BHARAT HEAVY ELECTRICALS LIMITED
PROJECT ENGINEERING MANAGEMENT, NOIDA

CORRIGENDUM- 03

PROJECTs	:	3X800 MW TALABIRA
PACKAGE	:	COOLING TOWER - Induced Draft Cooling Towers (IDCT)
Enquiry No.	:	77/23/6121/VIN Dated 18.09.24
SUBJECT	:	PRE-BID REPLIES

IDCT CONTOUR

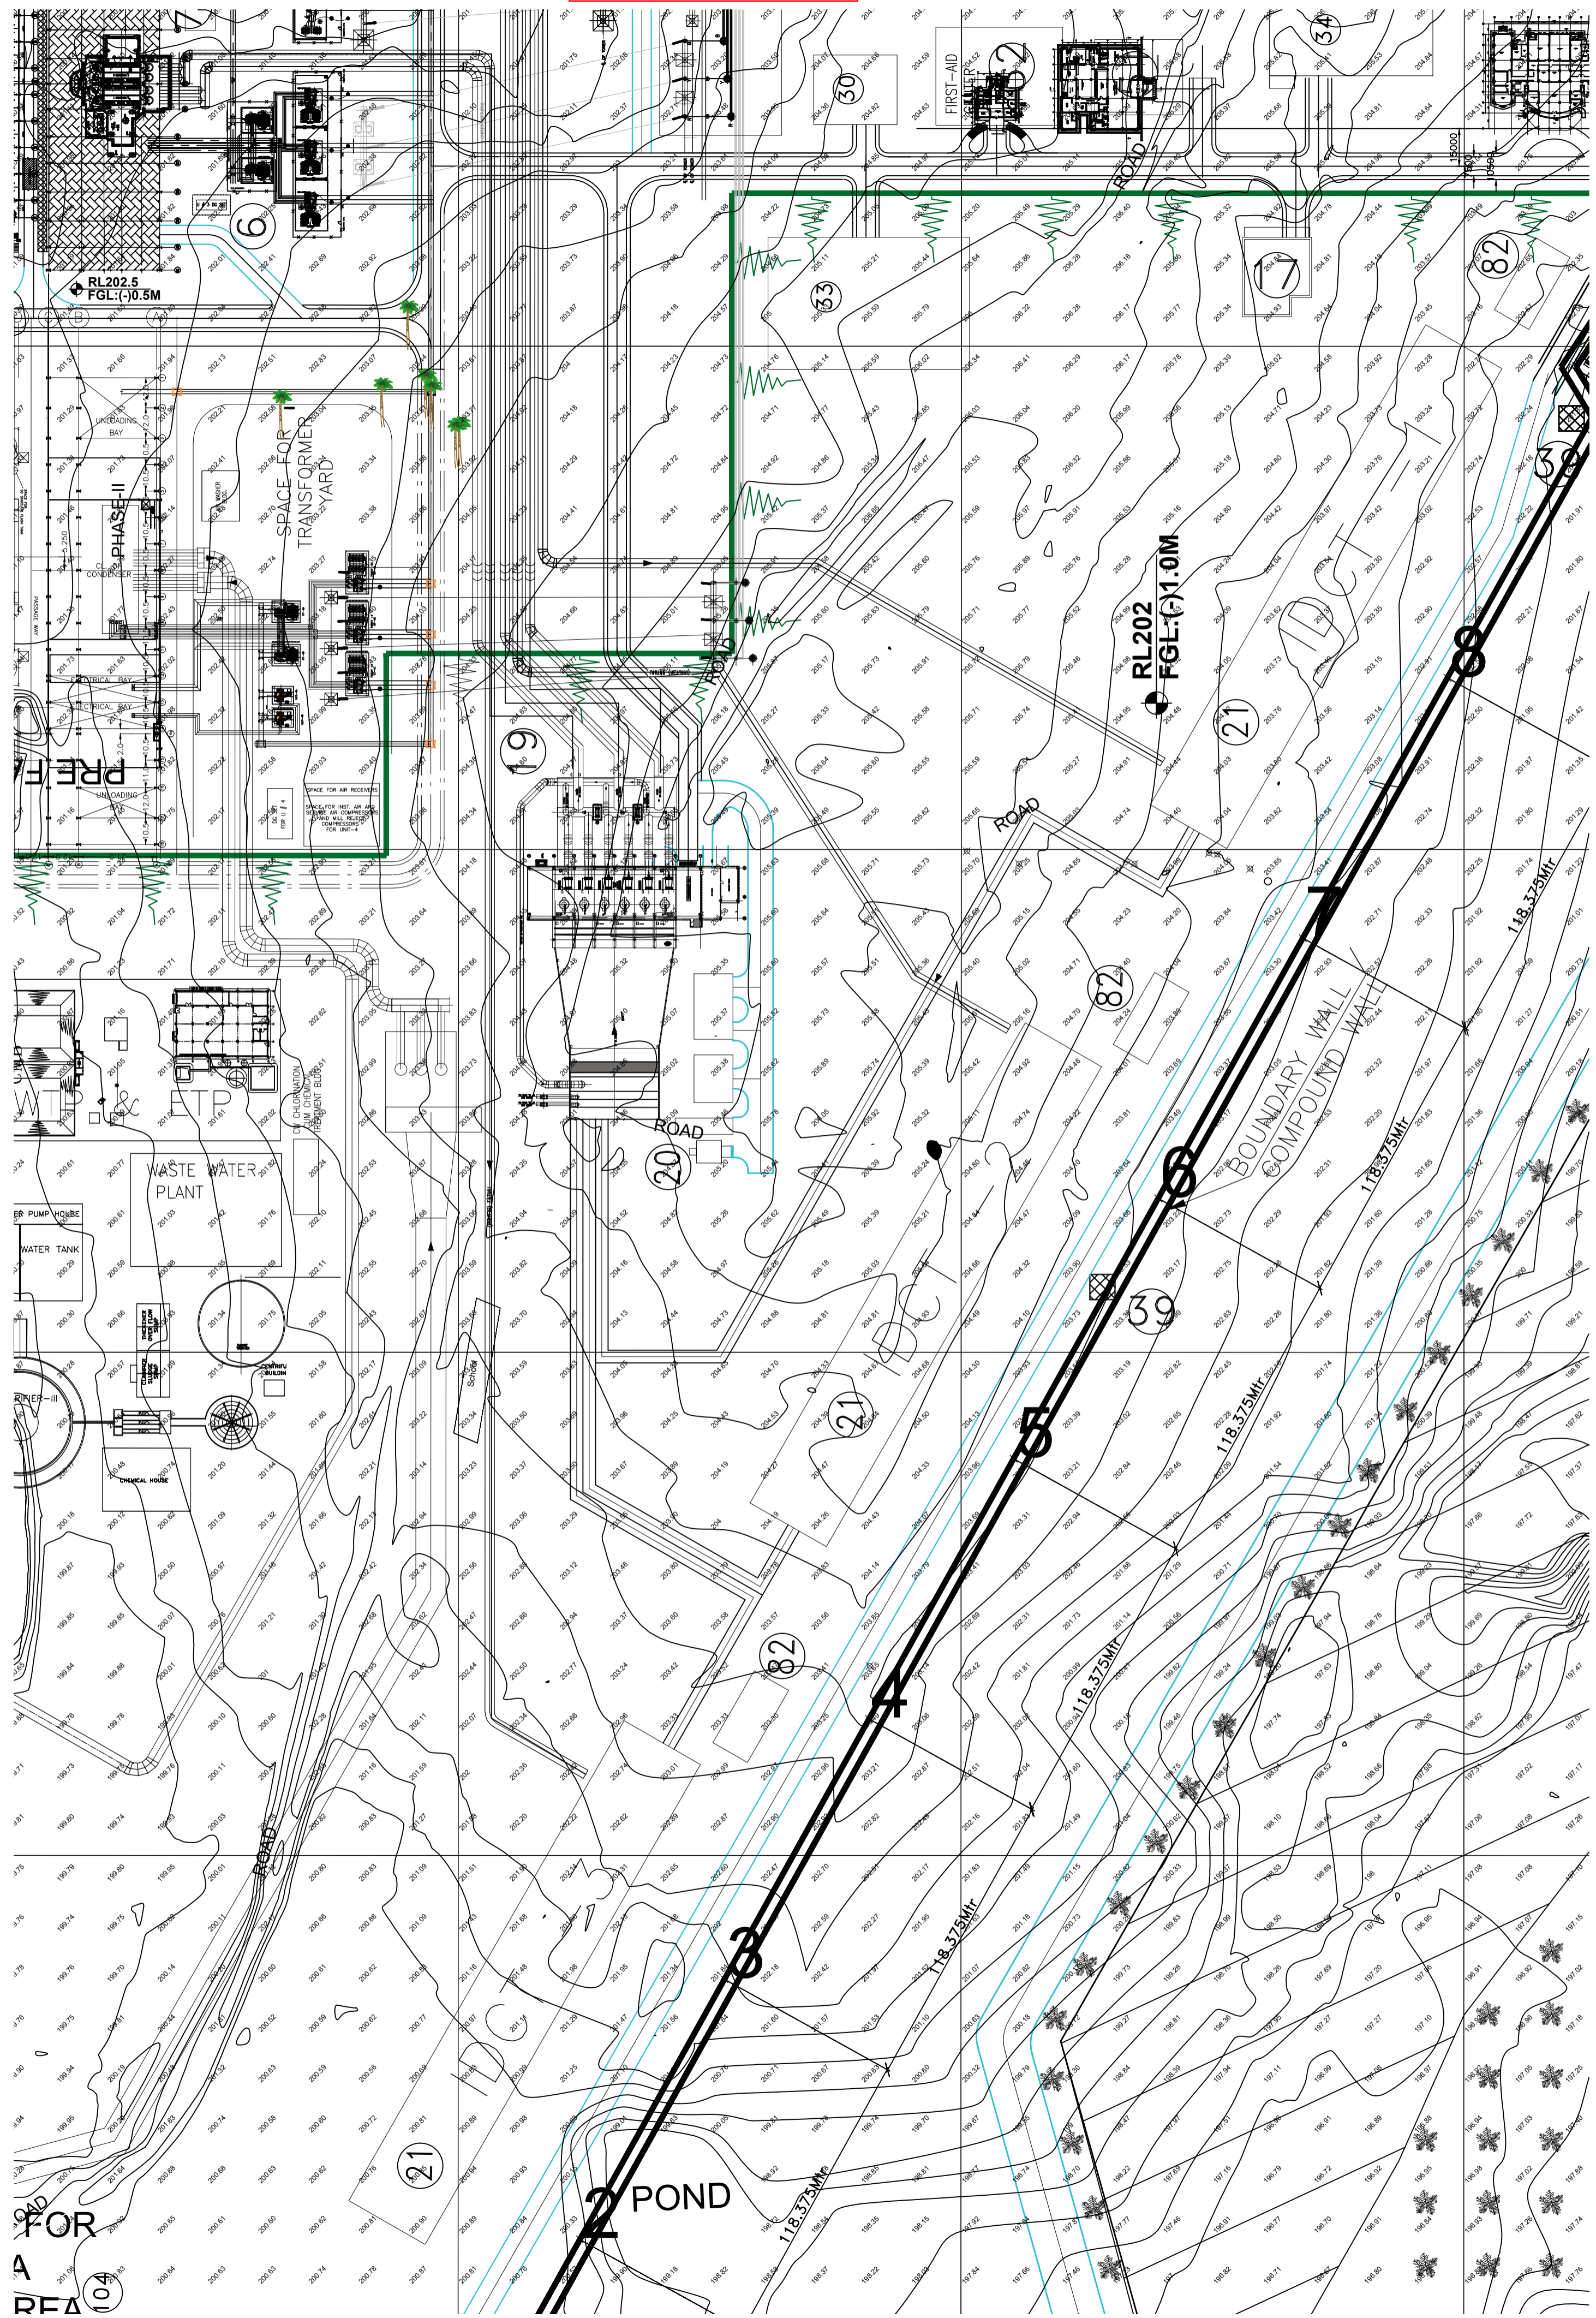
62	Technical Specification No. PE-TS-511-165-W001	Section - III	Page 18 (Tender Notice_20 / 57 of 404)	As per this clause FGL for IDCT area is RL 203.00 M. However, as per Technical Data - Part A (Mechanical) / SI No 2.26, FGL = RL 202.0 M. Please confirm the correct FGL for each IDCT. Also please confirm that IDCTs sites will be handed over to us by BHEL graded to FGL.	FGL for IDCT area is RL 202.0
63	Technical Specification No. PE-TS-511-165-W001	General	--	Kindly furnish the complete plant layout & contour drawing for our study.	Please refer specification for plant layout. Contour drawing is attached along with the replies.
